NOTICE OF DECISION

**DECISION OF THE PLANNING ADMINISTRATOR**

**TENTATIVE PARTITION PLAN CASE NO.: PAR25-01**

**LOCATION:** 4755 Gath Rd SE, Salem OR 97317

## 4755 GATH RD SE PARTITION TENTATIVE PLAN

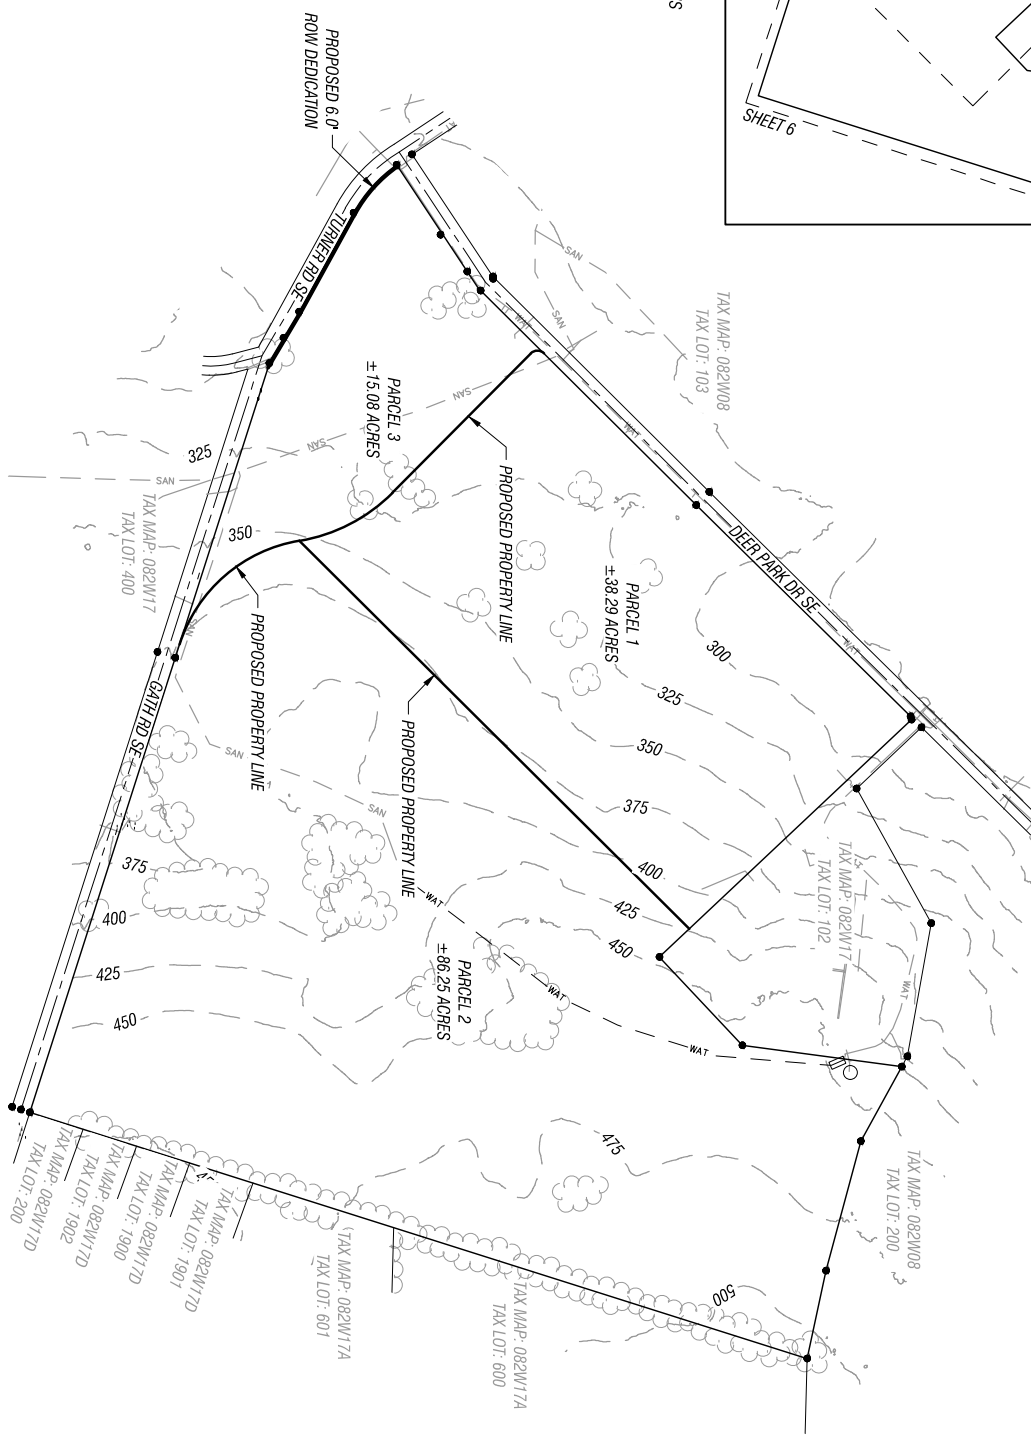
**Finding:** As shown on the tentative partition plan (**Attachment B**), proposed Parcel 1 is approximately 38.29-acres in size and will provide more than 1,670 feet of frontage on Deer Park Drive SE. Proposed Parcel 2 is approximately 86.25-acres in size, and will provide 1,550 feet of frontage on Gath Road SE. Proposed Parcel 3 is approximately 15.08-acres in size and will provide approximately 754 feet of frontage along Deer Park Drive SE and 1,760 feet of frontage along Turner Road SE. The proposed parcels meet the minimum size and street frontage requirements of the PS zone and are of sufficient size and dimension to permit future development of uses allowed within the zone. These standards are met.

**Finding:** Proposed Parcel 1 will be an interior lot with the front lot line abutting Deer Park Drive SE. Proposed Parcel 2 will be an interior lot with the front lot line abutting Gath Road SE. Proposed Parcel 3 is a corner lot with frontage along both Deer Park Drive SE and Turner Road SE. Parcel 3 exceeds the minimum lot width and depth on both street fronting sides; therefore, either lot line abutting Turner Road or Deer Park Drive can be designated as the front at the time of site plan review and building permit. These standards are met.

Finding: Any easements needed to serve the proposed parcels with City infrastructure shall be shown on the final plat. The applicant's tentative plan shows existing access and utility easements on the subject property.

**Finding:** The subject property has frontage along Gath Road SE, Turner Road SE, and Deer Park Drive SE. As described in the written findings below, these streets do not meet the right-of-way and/or improvement width requirements for their classifications according to SRC Chapter 803 and boundary street improvements are warranted. However; boundary street improvements will be listed as a condition of approval for future development on each lot in order to determine the proportionate impacts of each development on the transportation system. The following findings provide required improvements for each boundary street fronting the property.

*Turner Road SE* – This street is classified as a Minor Arterial Street according to the Salem Transportation System Plan (TSP). Turner Road SE has inadequate right-of-way width according to the standards set forth in Table 803-1 (Right-of-way Width) and inadequate improvement width according to the standards set forth in and Table 803-2 (Pavement Width). As a condition of approval for the partition, the applicant shall construct boundary

- Condition 1:** Prior to final plat, required right-of-way dedications and required easements shall be free and clear of encumbrances and liens unless an adjustment to SRC 200.050(d) is approved.

- Condition 3:** Prior to final plat, all necessary (existing and proposed) access and utility easements must be shown and recorded on the final plat.
- Condition 4:** At time of development on each lot with frontage along Gath Road SE, construct a half-street improvement along the frontage of Gath Road SE to Collector Street standards as specified in the City Street Design Standards and consistent with the provisions of SRC Chapter 803.

- Condition 5:** At time of development on each lot with frontage along Turner Road SE, construct a half-street improvement along the frontage of Turner Road SE to Minor Arterial Street standards as specified in the City Street Design Standards and consistent with the provisions of SRC Chapter 803.

- Condition 6:** On the final plat, convey land for dedication to equal a half-width right-of-way of 36-feet from centerline on the development side of Turner Road SE, including sufficient right-of-way to accommodate public infrastructure at the property corners
- Condition 7:** At time of development on each lot with frontage along Deer Park Drive SE, construct a half-street improvement along the frontage of Deer Park Drive SE to Collector Street standards as specified in the City Street Design Standards and consistent with the provisions of SRC Chapter 803
- Condition 8:** Prior to final plat approval, provide a 10-foot-wide public utility easement along the frontage of Gath Road SE, Turner Road SE, and Deer Park Drive SE on the final plat.

**Condition 8:** Prior to final plat approval, provide a 10-foot-wide public utility easement along the frontage of Gath Road SE, Turner Road SE, and Deer Park Drive SE on the final plat.
